AGENDA
OF THE
CITY OF WILDWOOD'S
ARCHITECTURAL REVIEW BOARD
CITY HALL COMMUNITY ROOM
16860 Main Street
Thursday, January 14, 2016 - 7:00 p.m. to 9:00 p.m.

4.I.i. A Presentation And Discussion Of The Preliminary Development Plan And Elevations For The CVS Pharmacy Located At The Southwest Corner Of State Route 109 And Manchester Road. The Architectural Review Board's Comments Will Be Forwarded To Planning And Zoning Commission And The Petitioner, Prior To The Scheduled Public Hearing. [Wards 1 & 8]

As part of the zoning process for any proposed development in the Town Center, the Department of Planning and Parks is now forwarding submitted application materials, including the Preliminary Development Plan and elevations, to the City's Architectural Review Board for comments. The comments from the Board are then submitted to the Planning and Zoning Commission and the Petitioner, prior to the public hearing on the matter.

Board members, alternates, and liaisons were provided with the application materials, Preliminary Development Plan, and elevations for the proposed development of a CVS Pharmacy, which is to be located at the southwest corner at the intersection of State Route 109

SITE PLAN NORTH

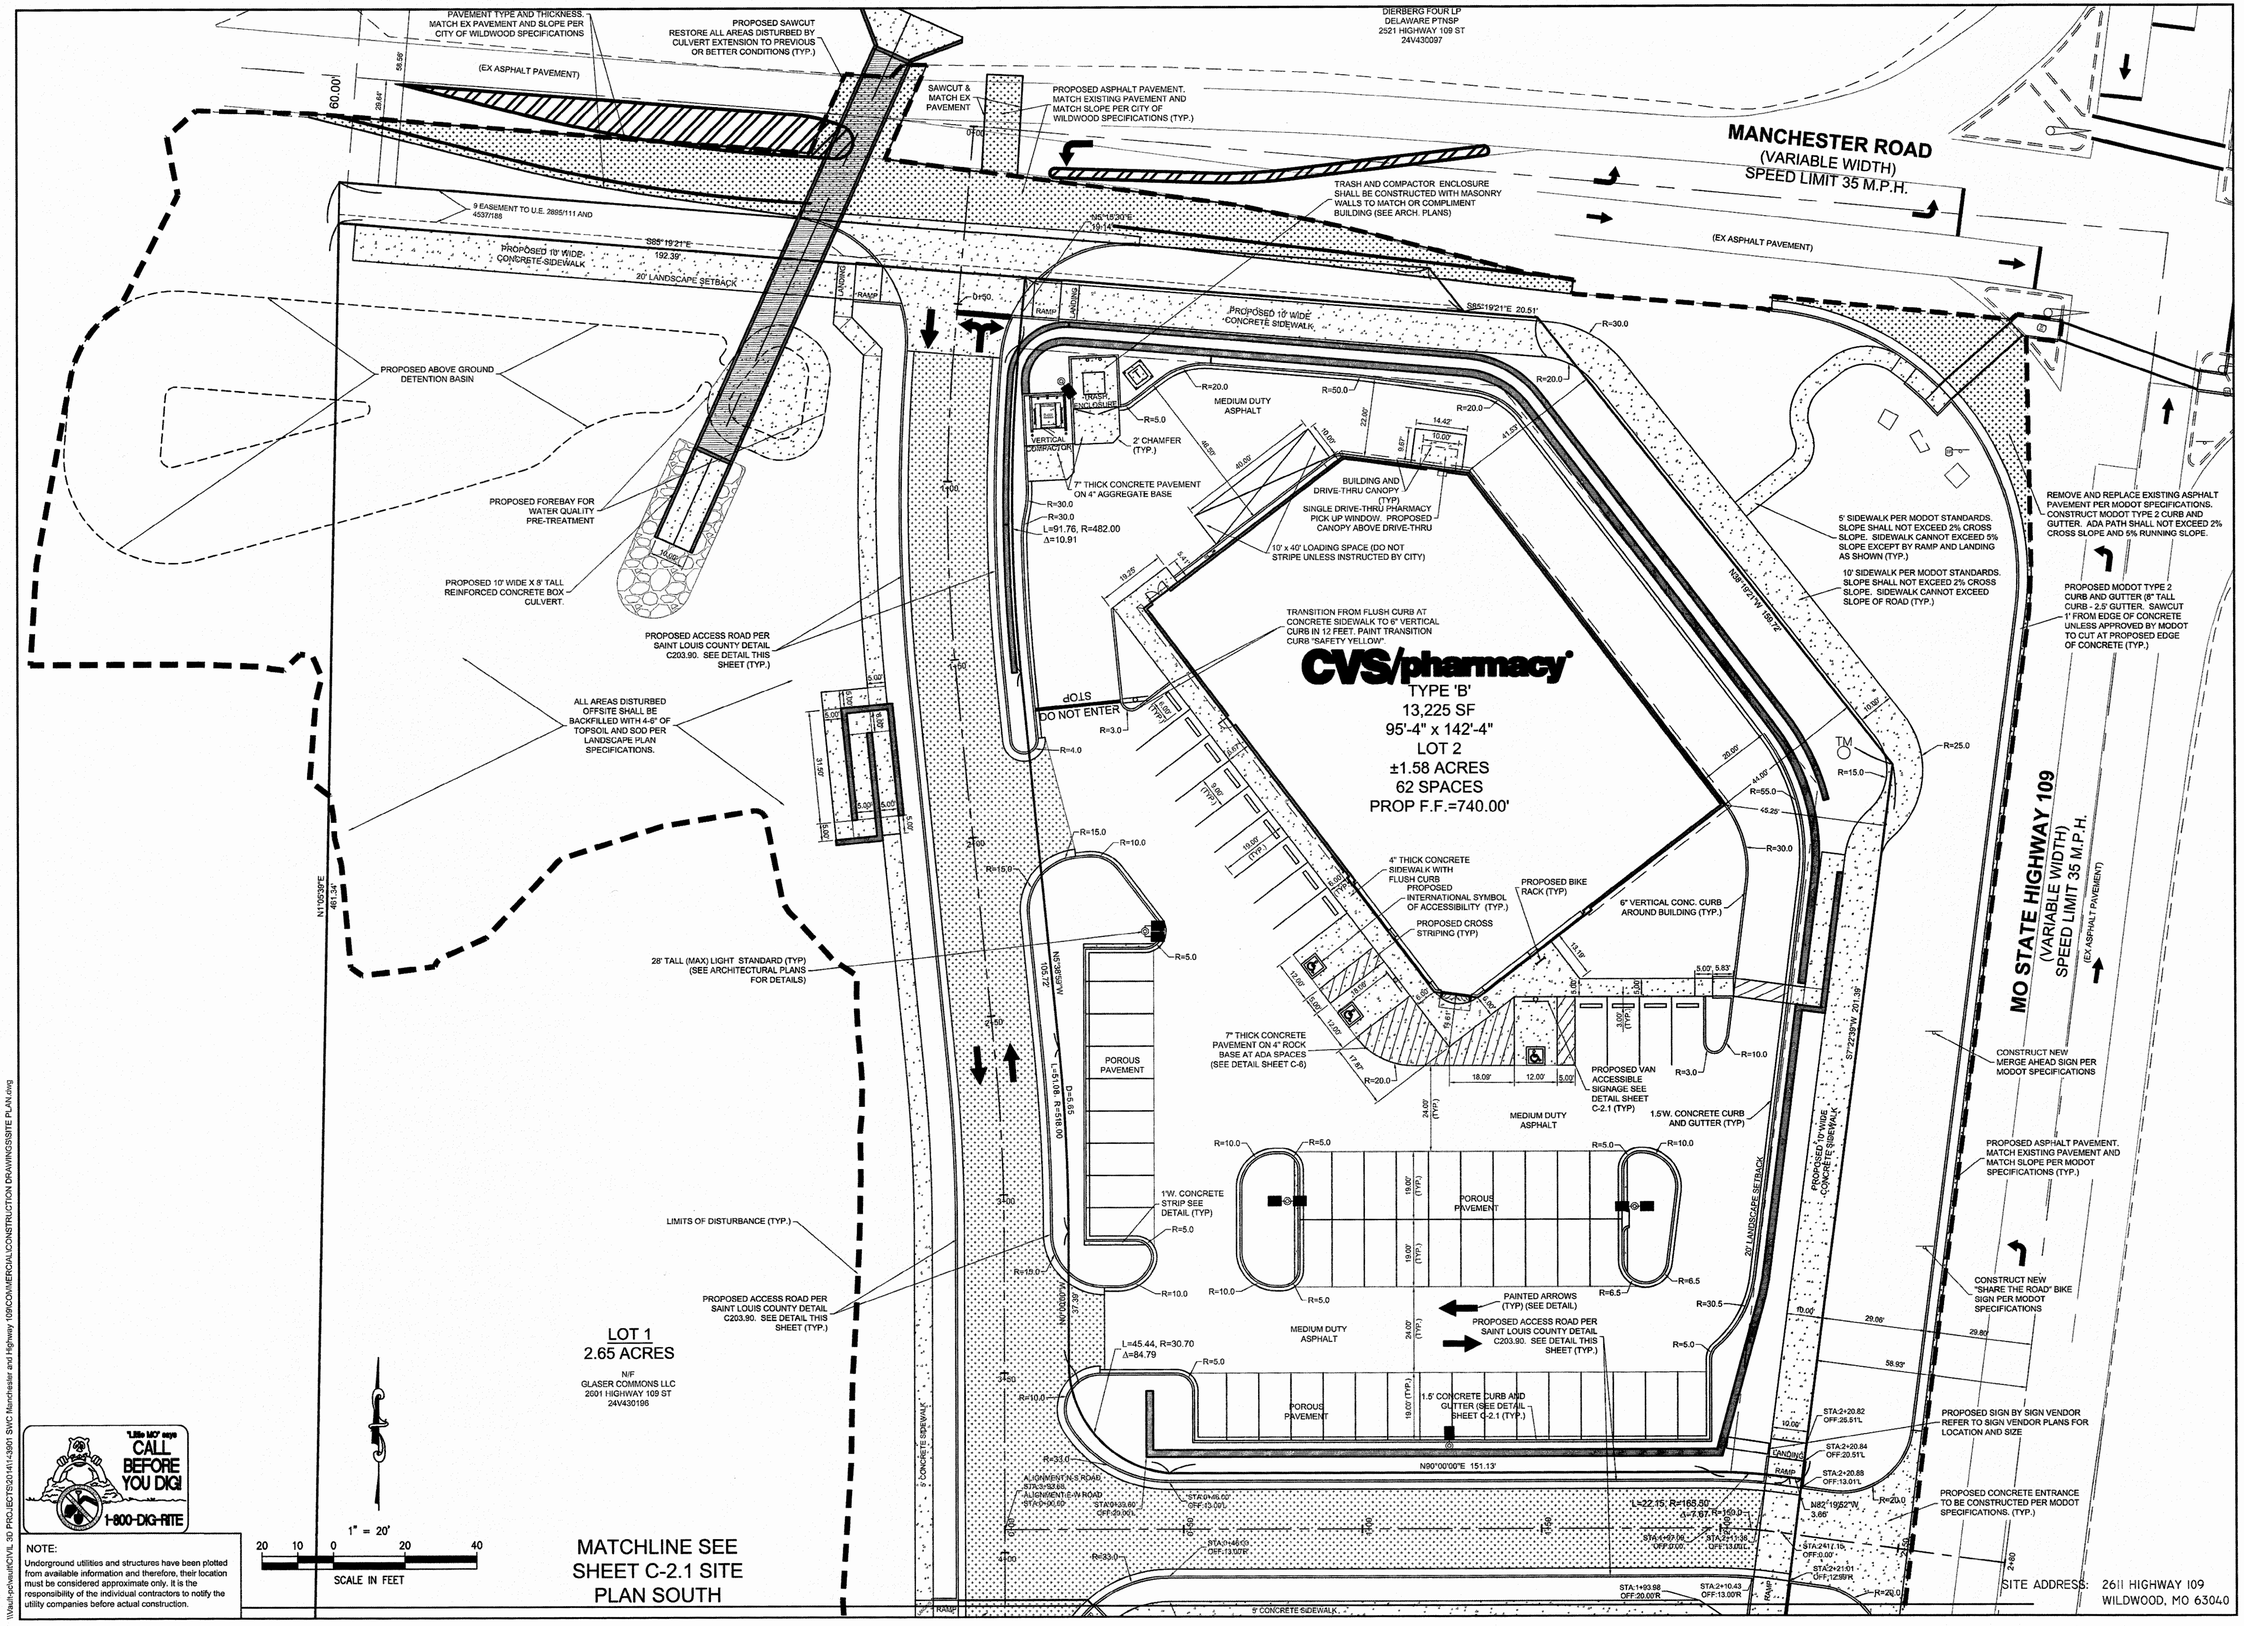
- Using this site plan as the beginning point for this project is the root cause all of the problems mentioned above. A better starting point, being a better site plan, will alleviate most, if not all, of the problems noted above.

- A better 'designed' site plan, and les of an 'engineered' site plan will be a good starting point.
- Conclusion: please start over, there is no way that I will vote for approval of this project on an ARB level – and I hope that this site plan would never get to that point.
